951 Gladstone Ave. & 145 Loretta Ave. North ▲

City of Ottawa Official Plan Policies

City of Ottawa Precon Design Feedback Comments

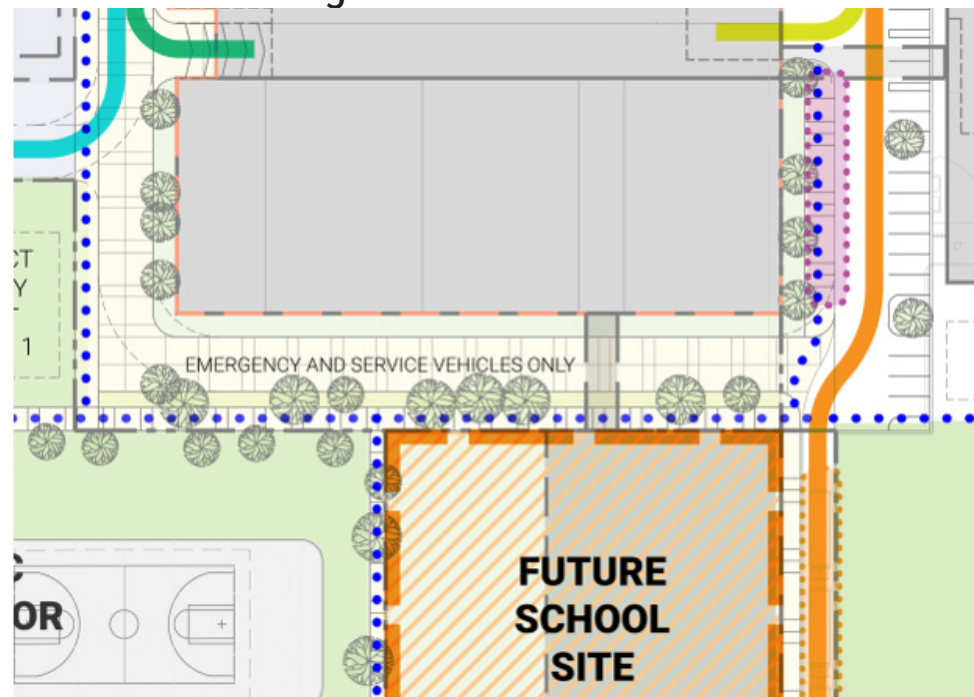
a. While the school does not meet the threshold for UDRP review, UDRP is recommended to review the school design in the context of the larger concept Master Plan. Further discussion about timing of submission to UDRP (formal vs. informal) can be proposed to ensure that UDRP submission aligns with the review of the concept Master Plan.

i. Staff have concerns with the interface with the service/loading area to the north, tree planting and soft landscaping should be provided to break up hard surface and define the pedestrian realm. Trees on either side of the sidewalk would be preferred if feasible. Setbacks on the school site may need to increase to accommodate this.

Response: As noted above, the school SPC application was incorporated with the overall concept UDRP for 1010 Somerset Community Hub amendments.

Response: The school site was intended to be reduced in order to fit the school footprint and playground. The sidewalk to the north of school along with the proposed looped road around the future RCF building will be designed by the City in conjunction with parks and is not part of the school development plan. The concept plan shows a strip of green between the public sidewalk and the road south of the future RCF building. See below

- CONCEPT SITE PLAN
- CONCEPT ELEVATIONS
- FLOOR PLANS
- LANDSCAPE CONCEPT

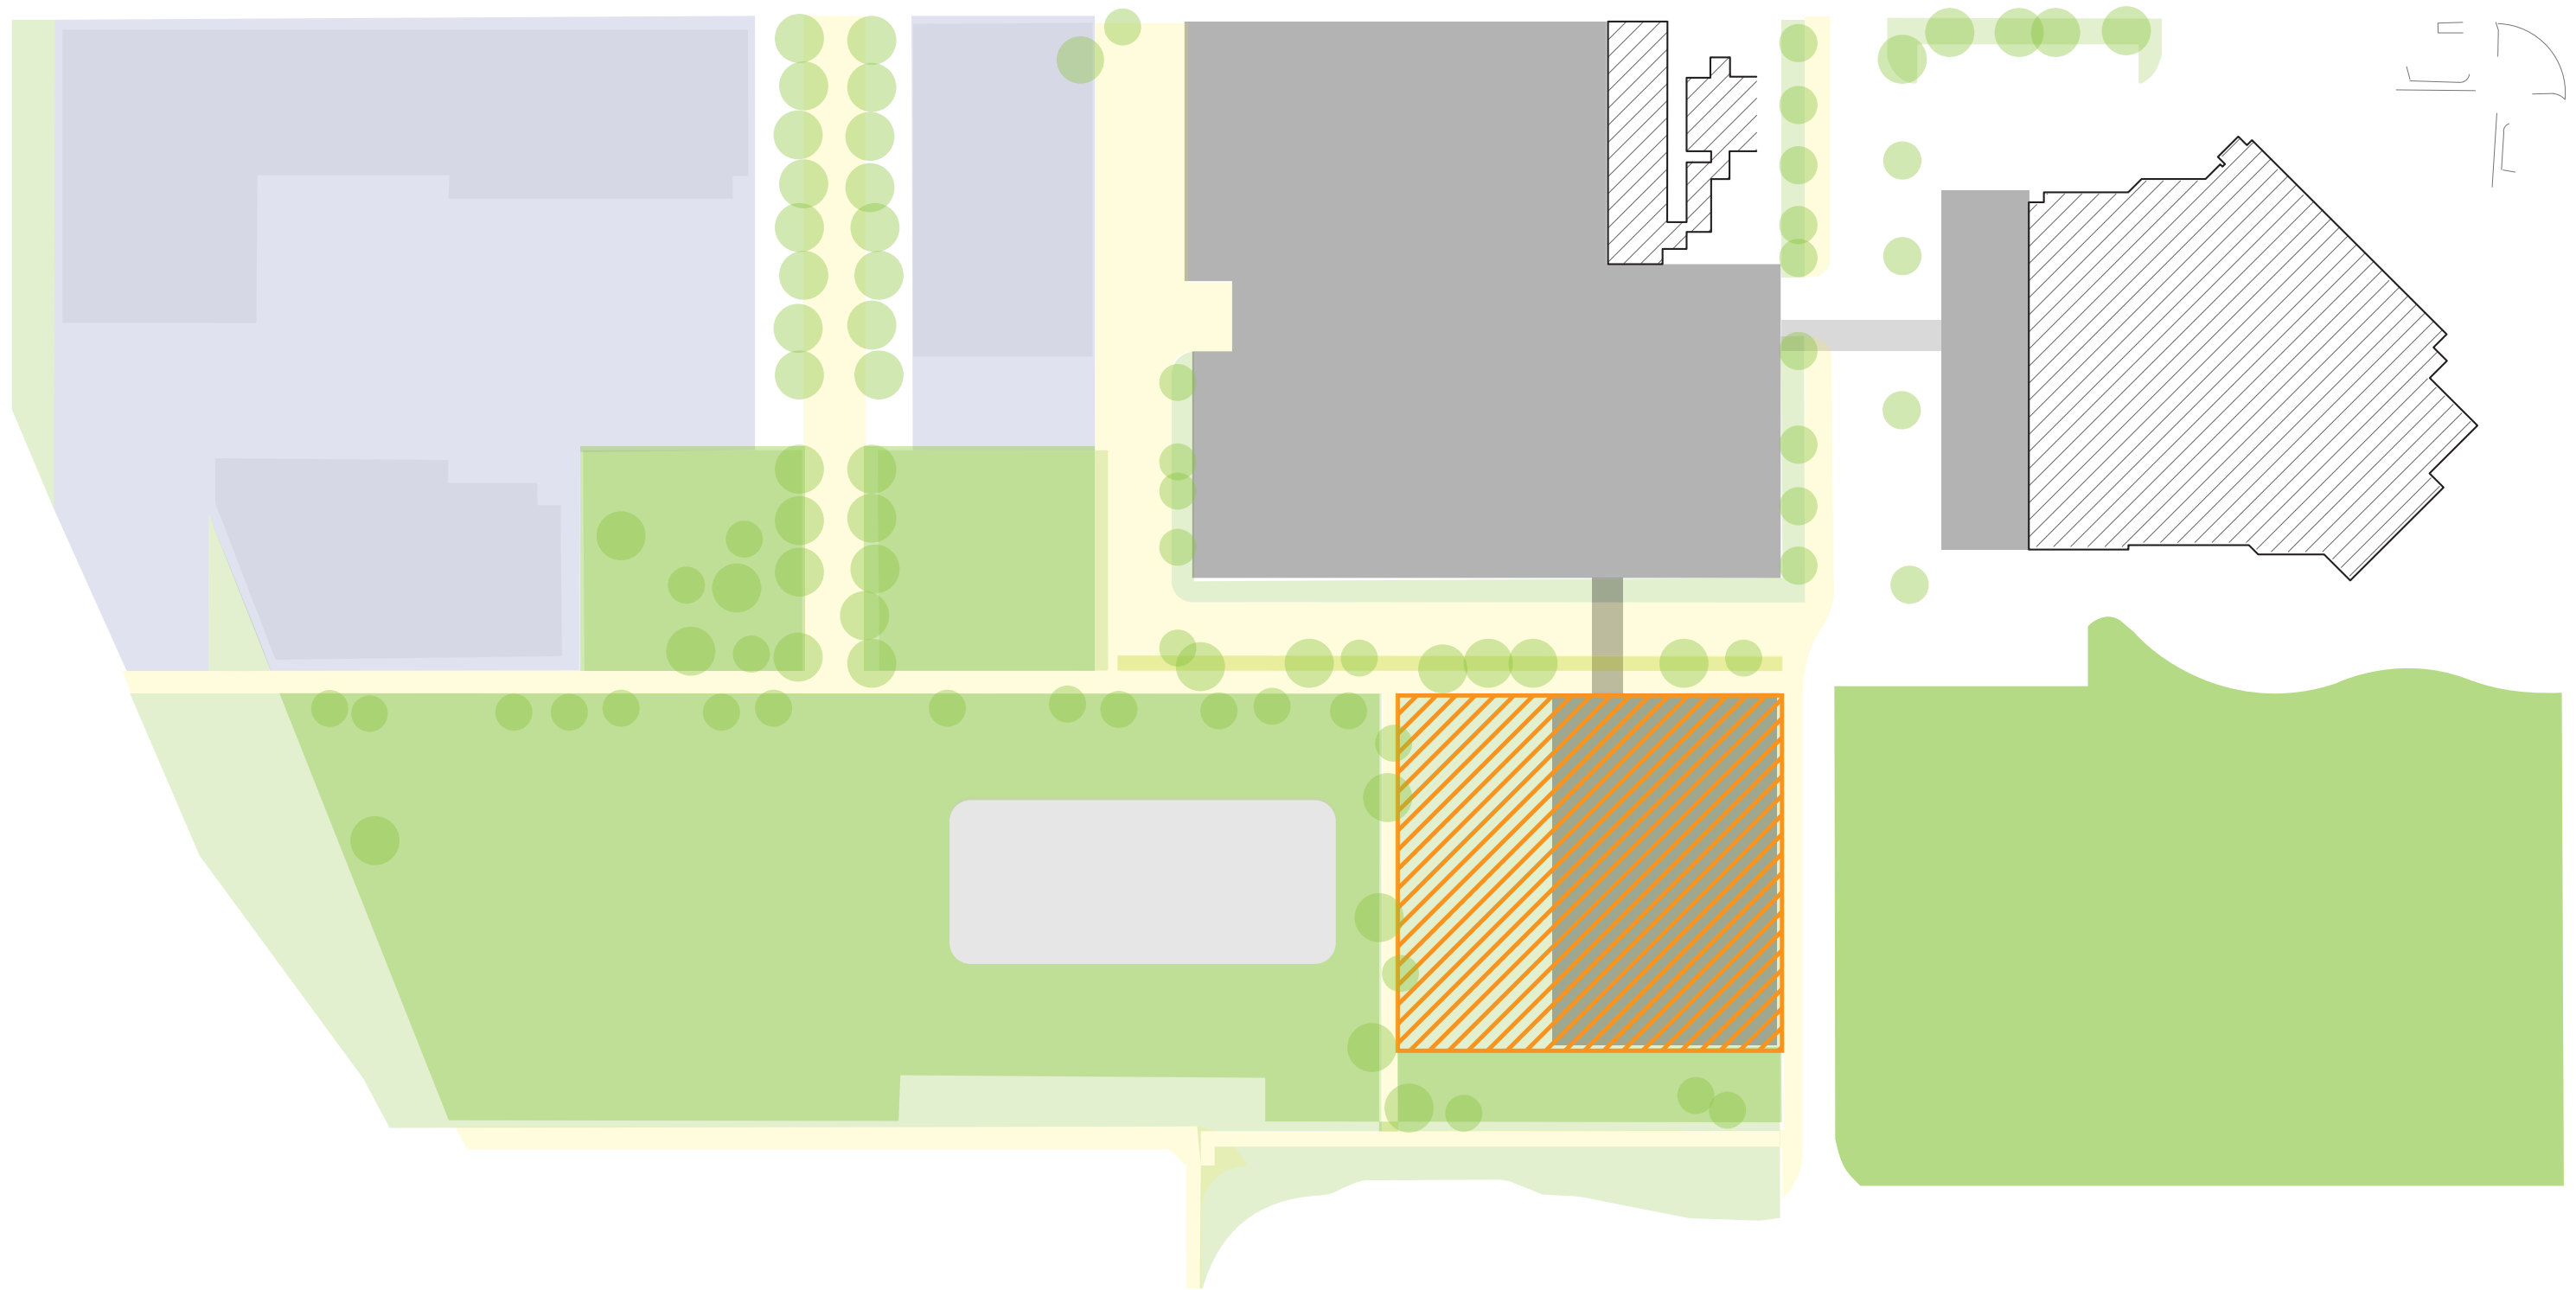
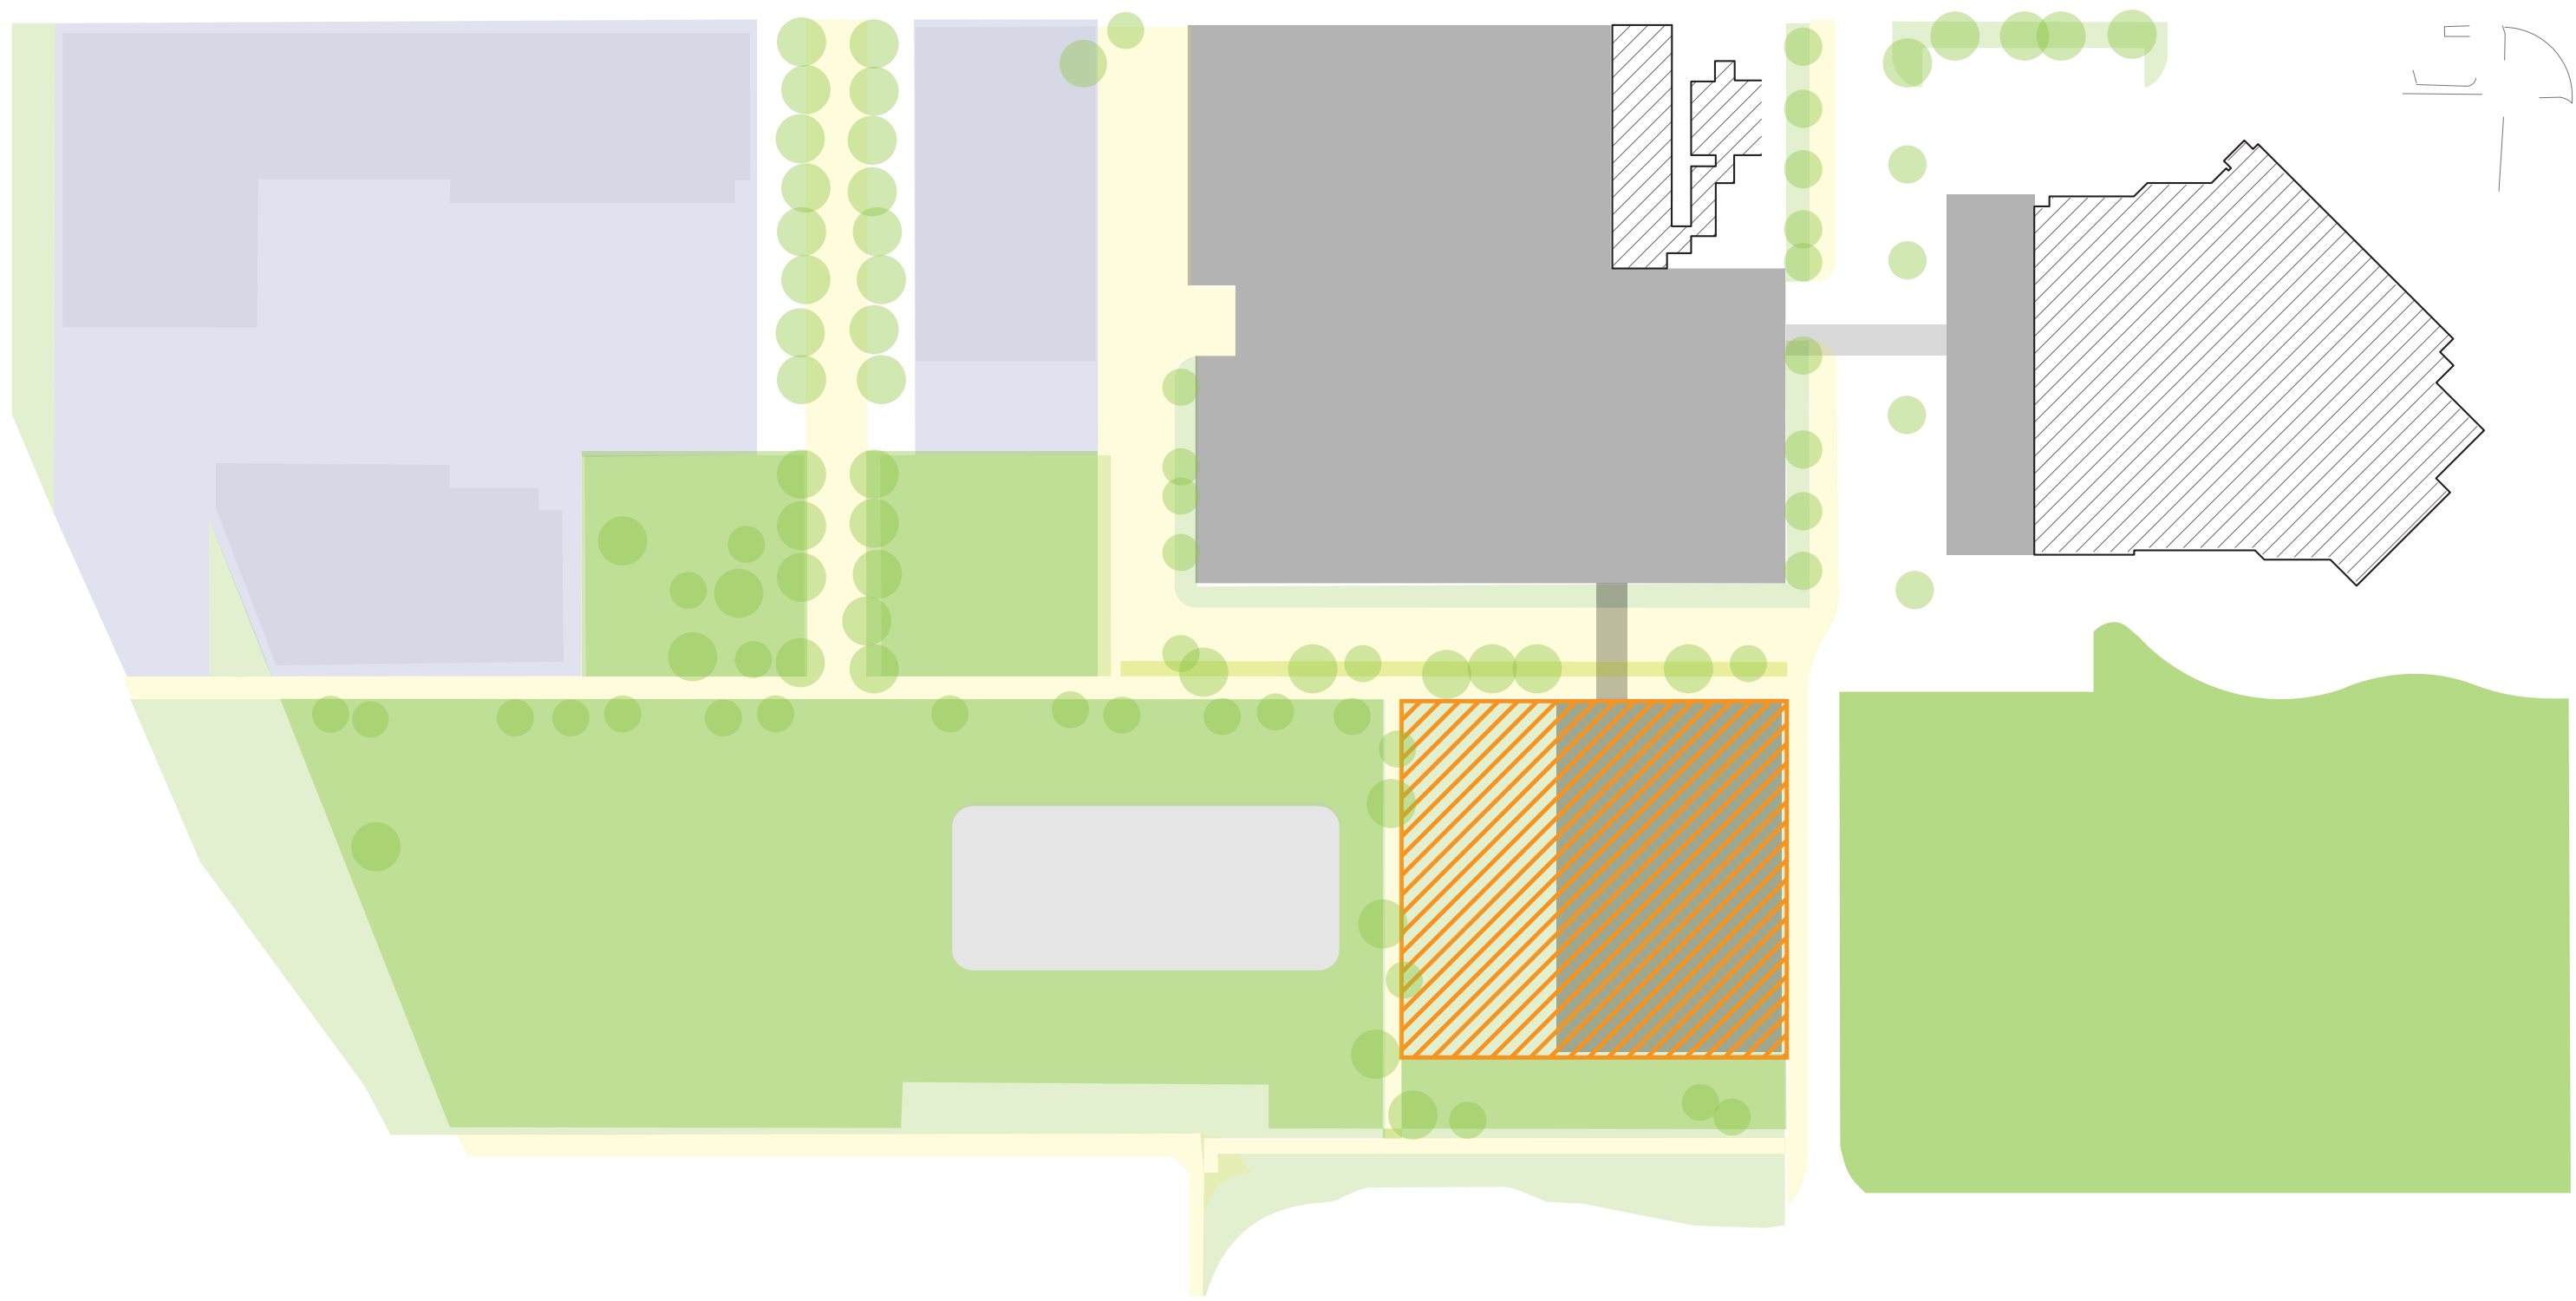
ii. Interface with Plouffe park and the bus lane is important, more detail is required to better understand this relationship.

iii. Treatment and layout of the public realm including sidewalks, landscaping and bus lane should be designed with the larger concept Master Plan in mind.

Response: The interface with Plouffe park and the bus lane has been very distinctly reviewed and approached. The current plan is to provide a sidewalk along the east side of the school which will run north-south and will connect at the south entrance of the school to inset pavers that delineate the connecting pathway to Plouffe Park. Part of the improvements will be to expand the existing retaining wall seating areas on the west side of Plouffe Park.

Response: The proposed sidewalks identified on the plan (north of the school, east of the school, and south of the school) are all intended to connect into a larger series of pedestrian routes in the community hub to be delineated and designed as part of the park planning process by the City. The project team has continued to coordinate with City staff in order to ensure that treatment and layout of the public realm and connecting pieces of the plan will be considered under the overall approved concept.
